MM912_634, Silicon Analog Mask (M91W) / Digital Mask (N53A) Errata

This errata document applies to the [MM912_634](#) product family.

Figure 1. Low-side Block Diagram

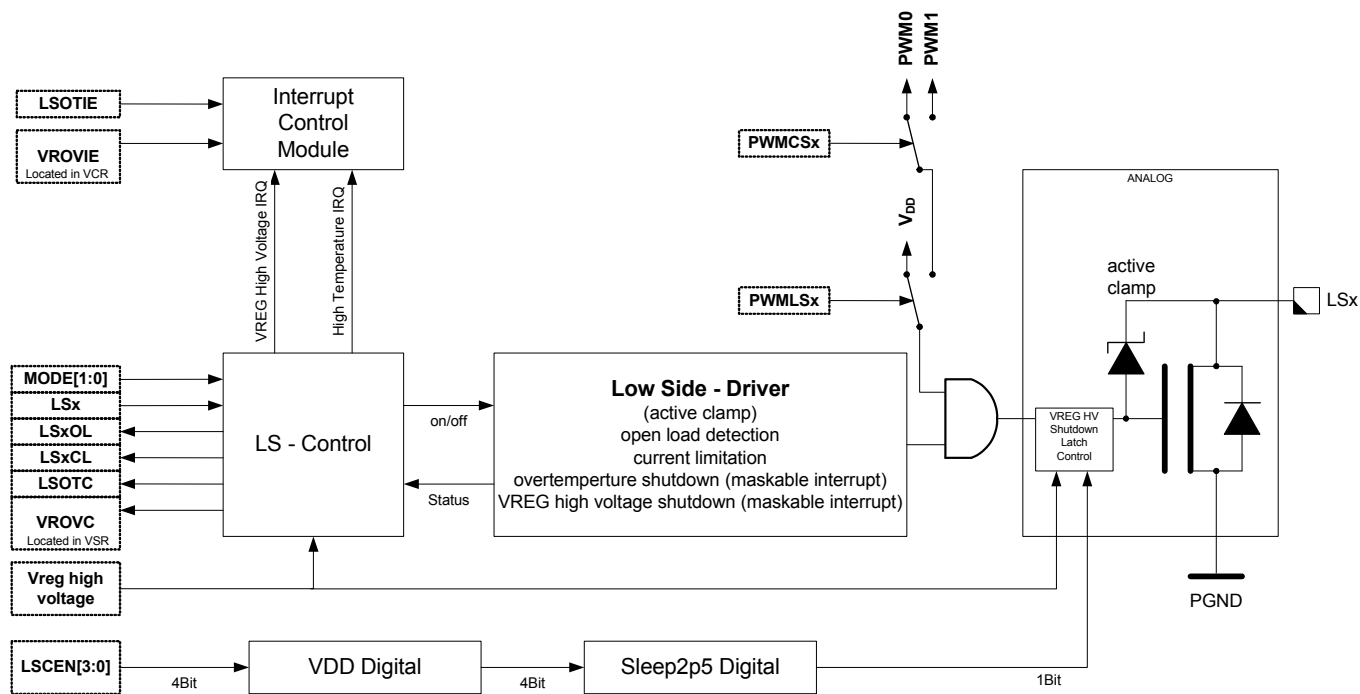
The Low-side Control Enable (LSCEN) register is reset only after LVR, LVRX and POR. It does not reset in case of an VREG Over-voltage event. See Figure 1. Low-side Block Diagram.

A digital implementation issue prevents the LSCEN register from resetting when a VREG high voltage condition occurs. The intent of the LSCEN register is to create a secondary deactivation stage for the low-side drivers, thereby verifying that the VDD-Digital and the Sleep2p5 Digital circuitry is functional after the occurrence of a VREG high voltage condition.

The Low-side Control Enable (LSCEN) register does not reset after a VREG Over-voltage event.

To maintain compatibility with a potential future silicon fix, Freescale recommends using the register write LSCEN=0x5 to re-enable the low-side.

Figure 2. Stop mode to Normal mode Transition

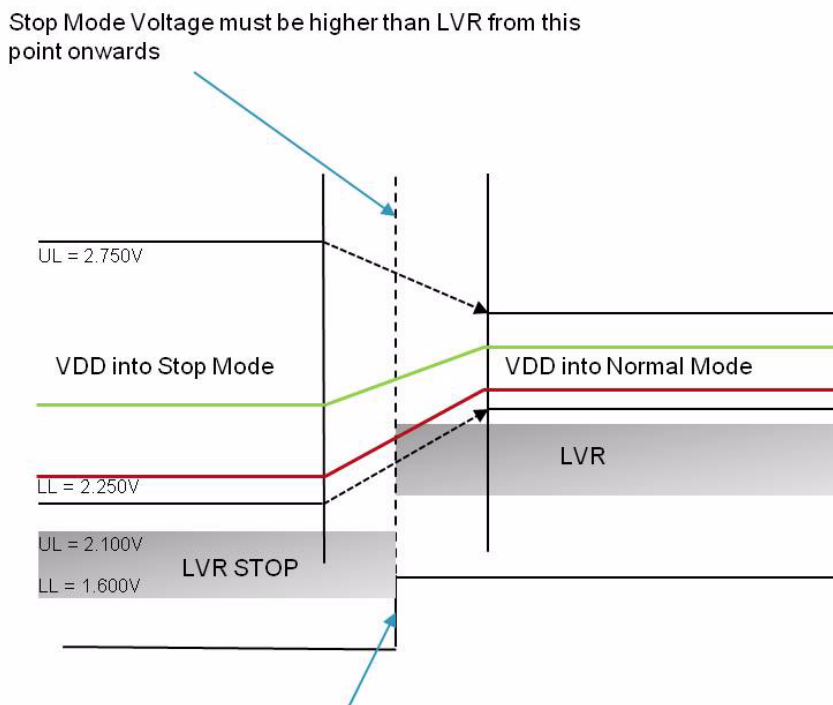
After a transition from Stop mode to Normal mode due to a wake-up event, the device may generate a Reset. If this occurs, the WUR bit in the RSR register is set until a reading of RSR register occurs. This behavior will affect parts with VDD in Stop mode below LVR in Normal mode.

When a wake-up event occurs, the transition from stop mode to normal mode begins. The VDD stop regulator switches to VDD normal regulator. The LVR normal mode is activated. If the actual VDD regulator output voltage is below LVR normal, the device generates a reset on the RESETA pin.

In **Figure 2**, the green line denotes a part that does not show this behavior. The red lines denotes a part that does show this behavior. The VDD parameter in Stop mode is distributed between 2.25 V and 2.75 V, while the LVR Normal is max 2.40 V. Only devices that have an actual VDD stop between 2.25 V and 2.40 V will exhibit this behavior.

The software recommendation to help minimize the impact of the behavior consists of verifying the Reset source after a wake-up. This check might be performed after a return from the reset sequence. If a reset occurs, the following flag is as described below:

Errata applies to the "C" version of silicon:

Errata corrected on the "D" version of silicon:
